Appendix E – Response to Comments

Response to Comments on the Draft Environmental Impact Statement for the MHA Nation's Proposed Clean Fuels Refinery Project

Figure 1 -- Plat designation for North East Boundary for Fort Berthold Reservation
1911

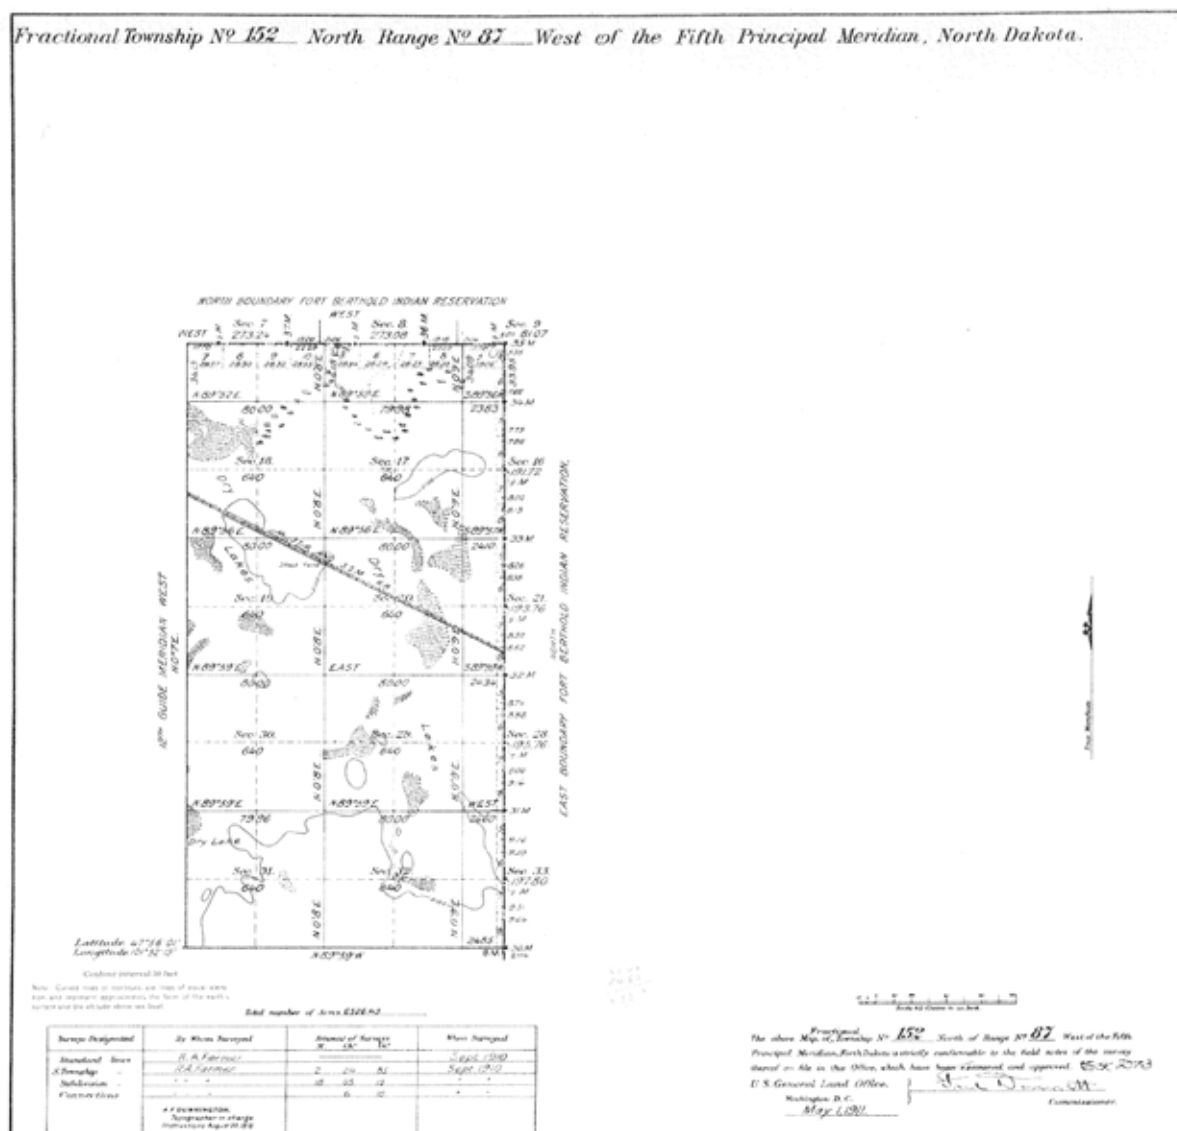
Comment 8: Comment that this project is not located within the exterior boundaries of the Fort Berthold Reservation

Response 8: The legal description for the project site is described as: N½ of Section 19, and the NW¼, Section 20, both located within Township 152 North, Range 87 West, 5th Principal Meridian, Ward County, North Dakota, containing 468.39 acres more or less after consideration of existing easements. This land is located on fee land within the exterior boundaries of the Fort Berthold Reservation. The following figure indicates the official north-east corner of the Fort Berthold Reservation.
